**SITE INSTRUCTION**

SIN NO: **19**  
 CONTRACTOR: **Mr. Pat Newton**  
**Talco Building Innovations Inc.**  
 4728 Bank Street  
 Ottawa ON K1T 3W7

PROJECT NAME: **225 Huntmar**  
**Ottawa, Ontario**

PROJECT NO: 15-010  
 DATE: 2020, Jun. 12

<p><b>SOPREMA</b> 1688, J-B Michaud Drummondville, QC J2C 8E9 WWW.SOPREMA.CA</p>		<p>COPYRIGHT 2015 SOPREMA</p>	
<p>TITLE: <b>SOPRAMASTIC BLOCK SYSTEM (HORIZONTAL)</b></p>		<p>DRAWING NUMBER: ACC-01</p>	
<p>PROJECT:</p>		<p>DATE: Nov. 2015</p>	
<p>SCALE: (N.T.S.)</p>		<p>PROJECT:</p>

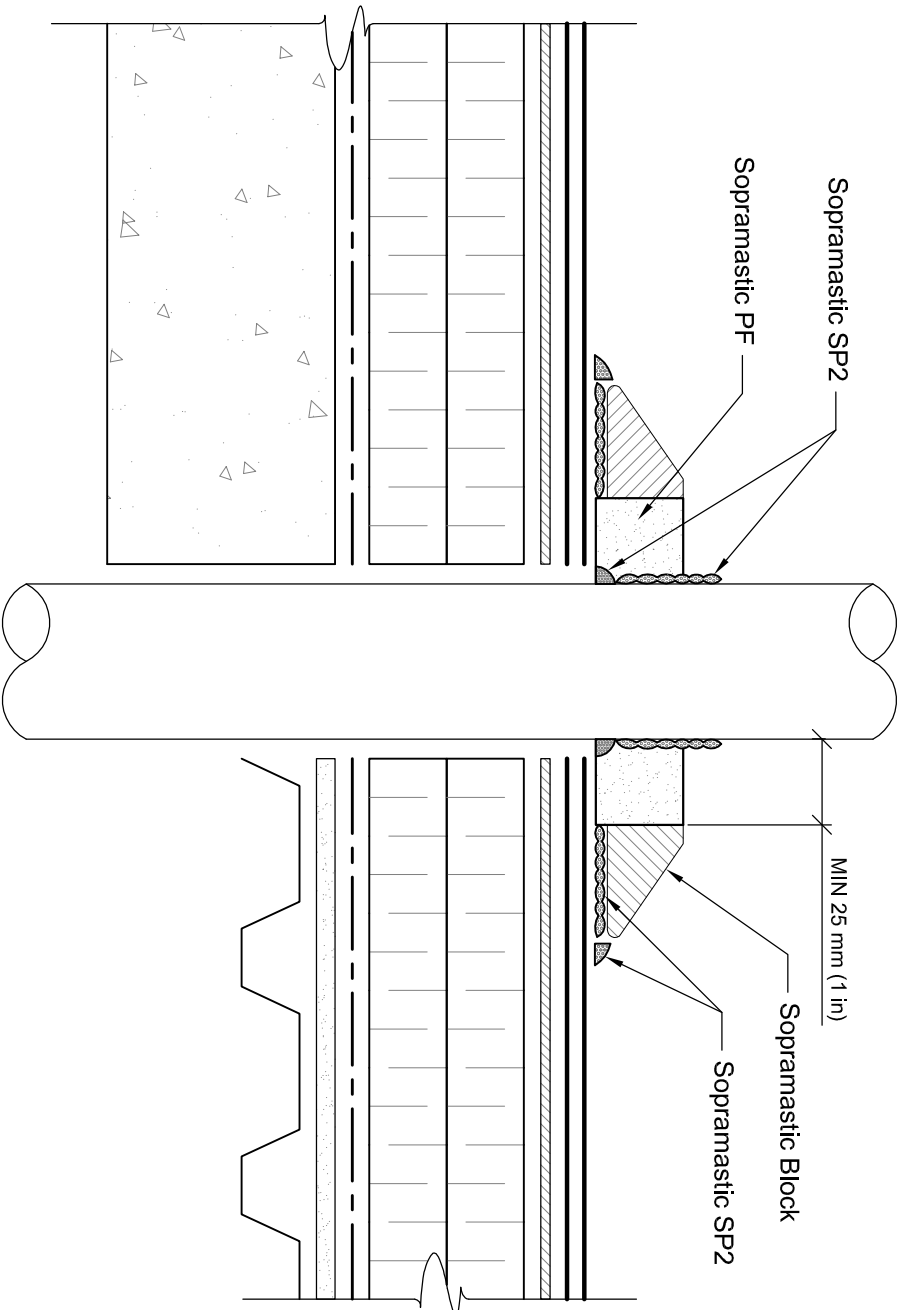
1. Further to contractors CIR #18. Please see attached detail for Soprema pitch pocket using "Sopremastic Block System" detail ACC-01. Suitable for sealing 38mm gas pipe roof penetration. Pleas adhere to manufacturer's guidelines for pipe size, as it relates to the gas line sizing.
